SERVICE INSTRUCTION

RansFlow Touchscreen Replacement Kit

Form No. SI-13-02
Litho in U.S.A.
04/13

| Fig.1 | Fig.2 | Fig.3 |

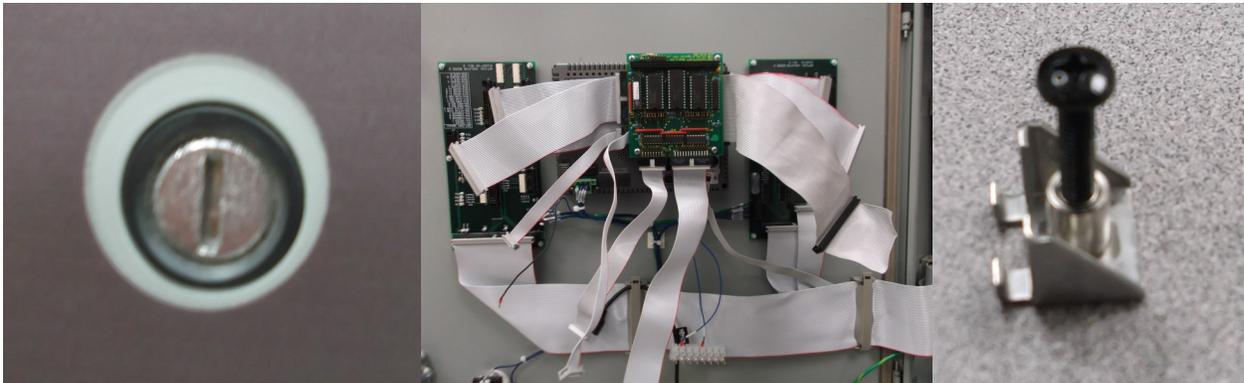
Using a large flat head screw driver, turn the two locks on the front of the panel to allow the door to be opened. (Fig.1)
Once inside the panel, locate and disconnect the ribbon cables from optical isolators boards A and B. (Fig.2)
Remove the power connector from the bottom left corner of the PC using a small flat head screw driver to loosen it.
Disconnect the db-9 connector that runs to the remote operator panel

Once all the cables are disconnected, use a small Phillips head screw driver to loosen and re-move all 6 retaining clips. (Fig.3)

| Fig.4 | Fig.5 | Fig.6 |

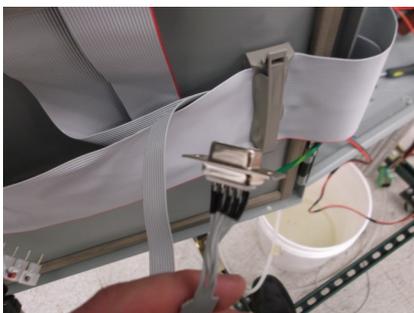
Find the existing 10 conductor cable assembly (Fig.4). Trace this cable back to its connection on the board at the top left of the of the case. Remove it and replace it with the new A13193-47 ribbon cable.

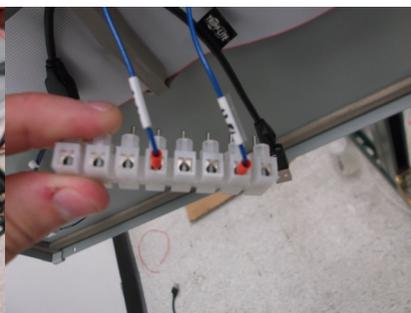
Now prepare the power connector for the new PC touchscreen (fig.5). Insert and tighten one 14" long piece of the 6655-13 wire in the 5v terminal (2^{nd} from the bottom) and one in the ground terminal (5^{th} from bottom).

The 24V signal and ground wires needed for this connector can be found on the lower right hand side of optical isolator board B.

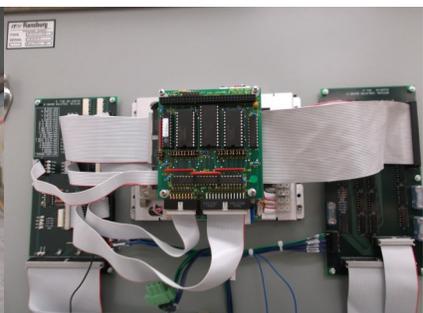
Connect all ribbon cables to the optical isolator boards. (Fig.6)
